Spartan Motors Chassis, Inc.

SERVICE BULLETIN

RSB13-270-002

SUBJECT: Breaking engine cooling fans

FIG. 3-1

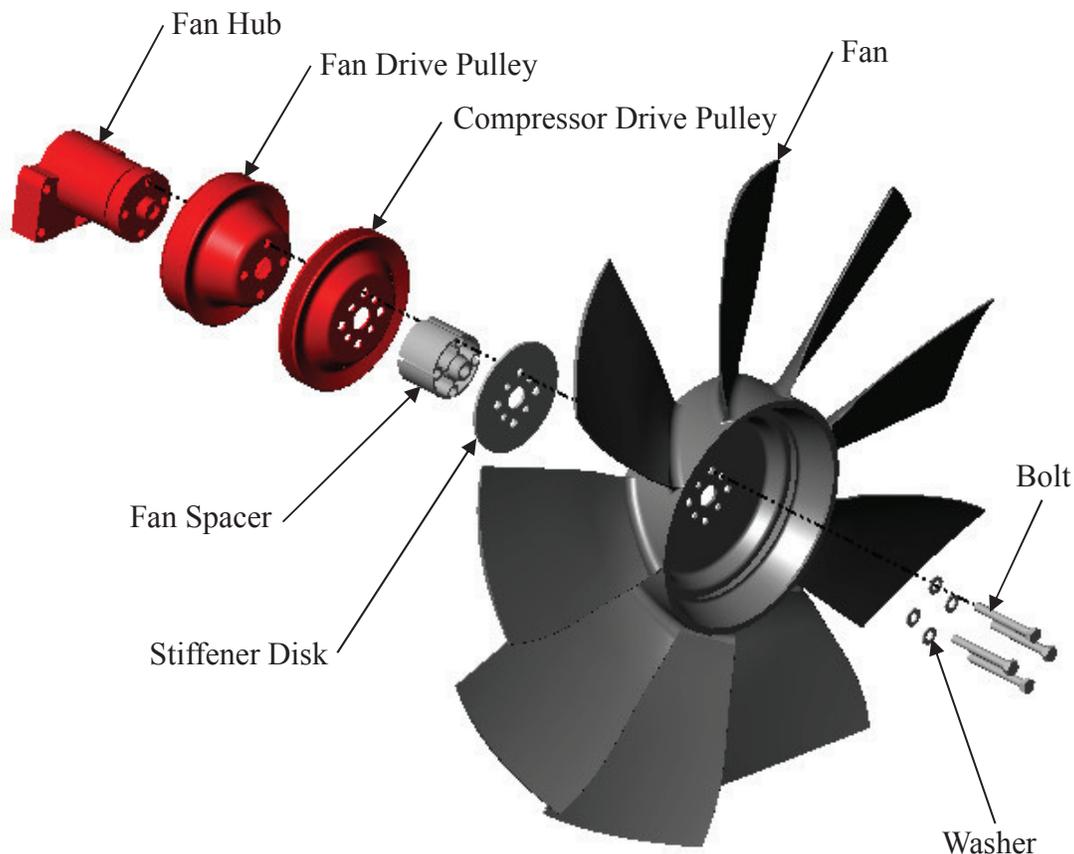
5. Remove engine cooling fan. Retain one of the fan spacers for re-use; properly dispose of the other one. Retain one of the bolts for use as an alignment tool and properly dispose of the fan and remaining hardware.
6. Inspect fan hub per Cummins procedure 008-036. If the hub is not suitable for re-use, replace the hub per Cummins TSB130052.
7. Cut the head off the fan attachment bolt retained in step 5.
8. Thread the headless bolt into one of the fan attachment holes of the fan hub.
9. Using the headless bolt as a temporary alignment guide; slide the fan drive pulley, compressor drive pulley, fan spacer, stiffener disk and fan onto the hub. Refer to FIG. 3-1.

10. Install new fan attachment washer and bolts, removing the temporary alignment guide. Apply Loctite 242[®] to the first 5 threads of the bolts. Torque bolts to 45-55 lbs. ft.
